HISTORIC AND DESIGN REVIEW COMMISSION

HDRC CASE NO: 2020-062
ADDRESS: 3101 ROSELAWN
LEGAL DESCRIPTION: NCB 12308 BLK 10 LOT 2
ZONING: R-6
CITY COUNCIL DIST.: 5
APPLICANT: Mark Padilla/MP Studio LA
OWNER: Pat Schneider/CITY OF SAN ANTONIO TCI
TYPE OF WORK: Park improvement
APPLICATION RECEIVED: January 24, 2020
60-DAY REVIEW: March 24, 2020
CASE MANAGER: Rachel Rettaliata

1. Repair/replace existing basketball court,
2. Demolish two 1-foot areas of the basketball court to accommodate piers for a new shade structure,
3. Install a new shade structure on one court to match existing,
4. Remove existing lighting and install new court lighting.

1 KENNEDY PARK BASKETBALL COURT DEMO
PLAN

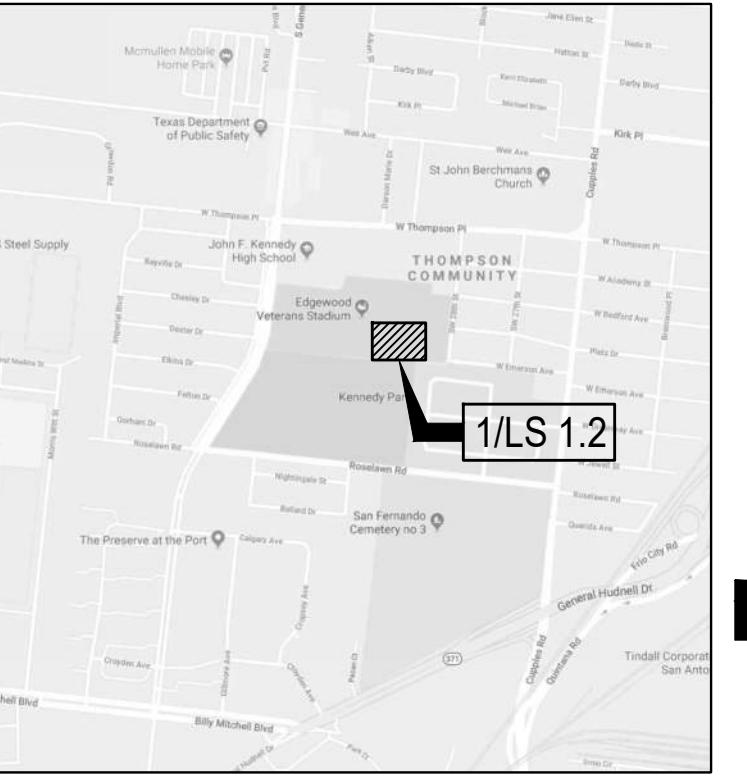
- c. PARTIAL DEMOLITION – The applicant has proposed to demolish two 1-foot areas of the basketball court to accommodate the piers for a new shade structure to match the existing shade structure. Staff finds the proposal generally appropriate.

N
1 BASKETBALL COURT - DEMO ELECTRICAL SITE PLAN

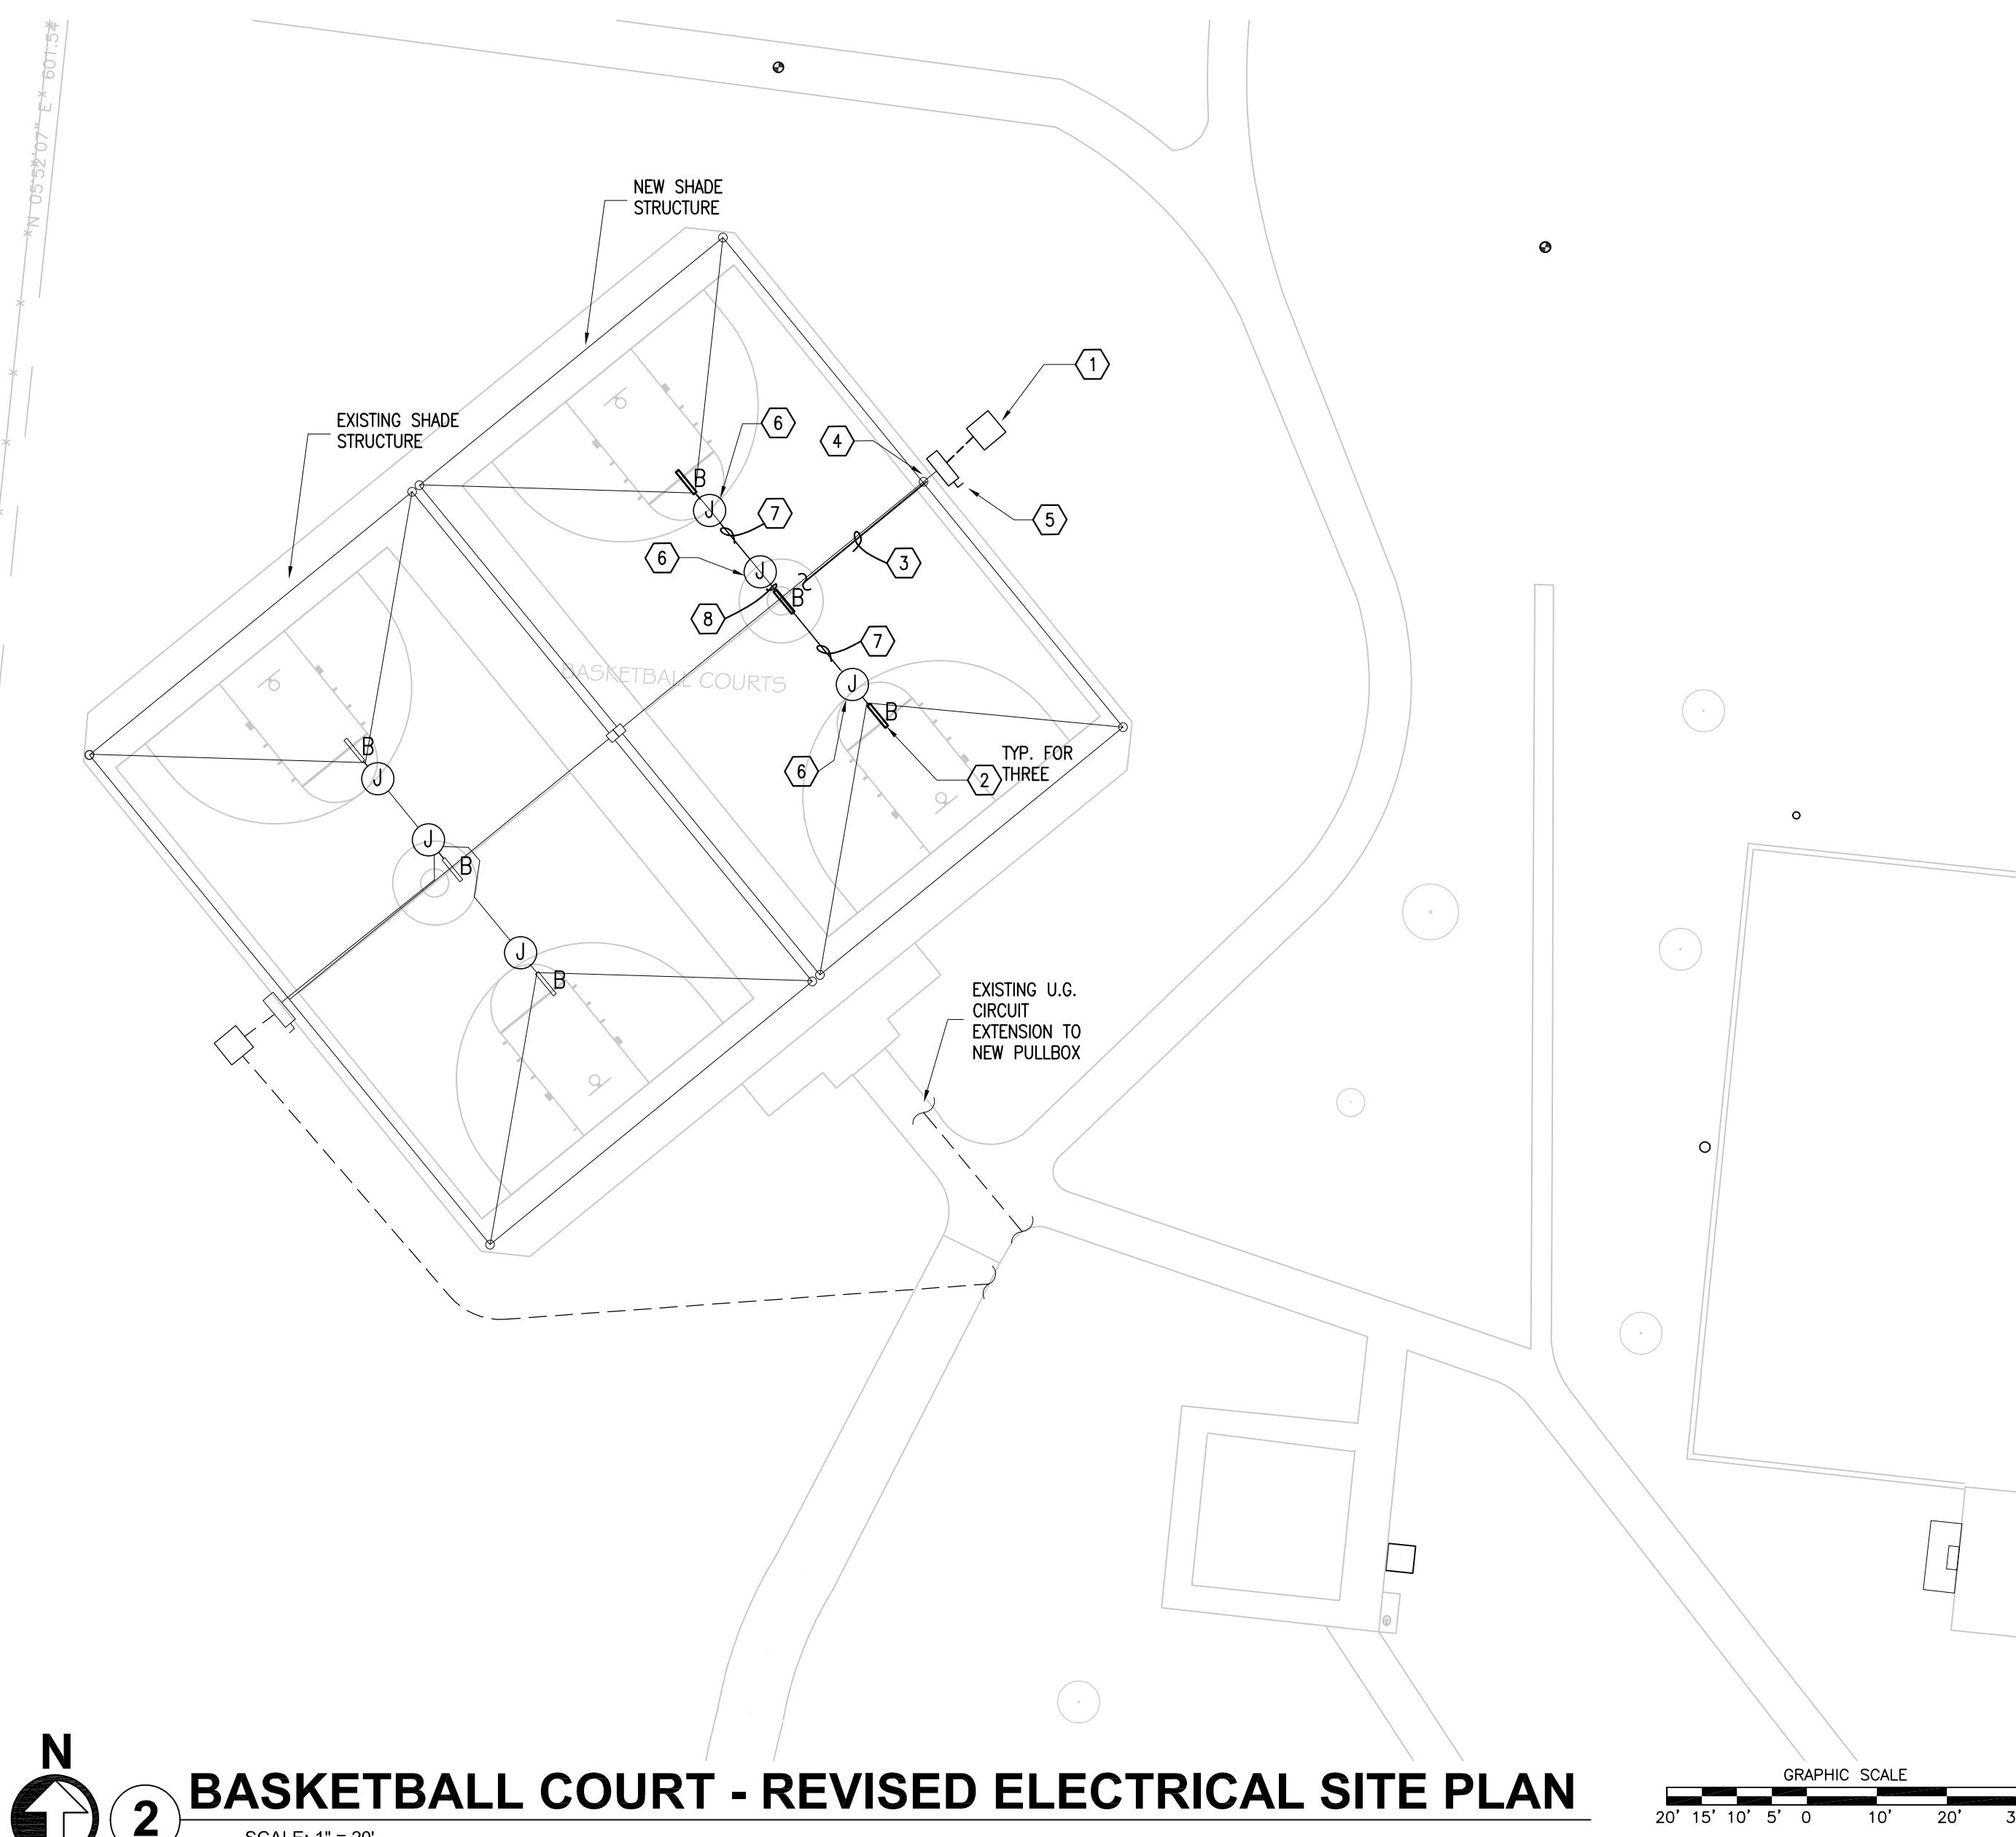
- e. PARK LIGHTING – The applicant has proposed to remove existing lighting in order to install an electrical conduit for new L.E.D. basketball court lighting. Staff finds the proposal generally consistent with the UDC Sec. 35-642 (b).
